EcoRoute Ref.: 001

30 March 2026

PROJECT: PROPOSED RESIDENTIAL DWELLING ON PORTION 76 OF FARM UITZICHT NO. 216, KNYSNA, WESTERN CAPE: DRAFT BASIC ASSESSMENT REPORT – COMMENTS RESPONSE LETTER

Fig 1 Portion 76 in relation to Portions 74 and 75

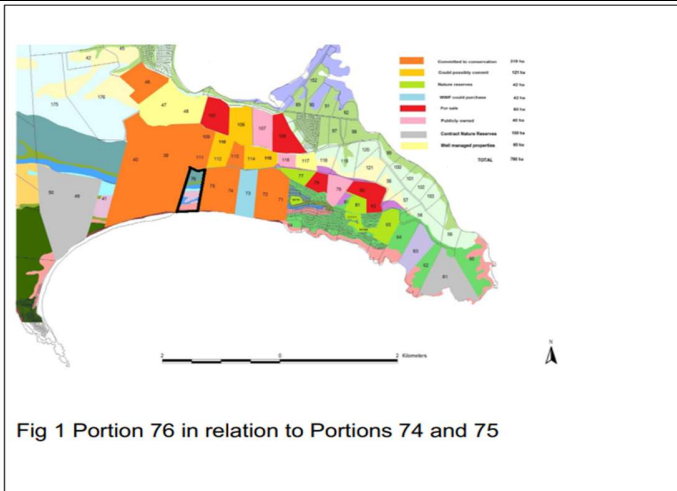
<p>Re: Objection to the Proposed Development of Portion 76 (A Portion of Portion 54) of Farm 216 Uitzicht, Knysna, Western Cape. As set out in the Draft Basic Assessment Report by Eco Route.</p> <p>I hereby object to the proposed development and support the objections submitted by the Western Heads Gougamma Conservancy and SANParks in this regard. I am owner of the portion 74 and 75 Uitsicht which I bought with the sole intention to help save this sensitive area for his environmental value and as a natural ecologically pristine area for generations to come. Portion 76 falls within an exceptionally sensitive biodiversity area as per SANBI Biodiversity classification, and is a core conservation area. I share a boundary with portion Uitsicht portion 75 and both the portions 74 and 75 look directly onto the dunes where the intended development is proposed. We also share an access road which runs on the Northern boundary of both my properties. Portion 74 and 75 are already committed to be included into SANparks due to their important conservation value.</p>	<p>The objection and background information are noted. The environmental sensitivity of the property and the broader conservation context have been acknowledged in the Draft Basic Assessment Report (DBAR) and specialist studies. The application is for a single dwelling exercising primary land use rights, and the development footprint has been significantly reduced in scale and carefully positioned based on specialist input and site constraints. The majority of the property will remain in a natural state and mitigation measures are included in the Environmental Management Programme (EMPr) to minimise ecological disturbance.</p>

The comment is noted. The proposed dwelling has been reduced in size from the originally proposed 3000 m² to approximately 1000 m² (including verandas and garage), and the total disturbance footprint is limited to approximately 0.25 ha. The application is strictly for a single residential dwelling and not for commercial use. Any future change in land use would require a separate land use application and environmental process, if applicable. The location of the dwelling was determined through an alternatives assessment and specialist input, taking into account environmental, geotechnical, access and services constraints. Mitigation measures are included to minimise visual and ecological impacts.
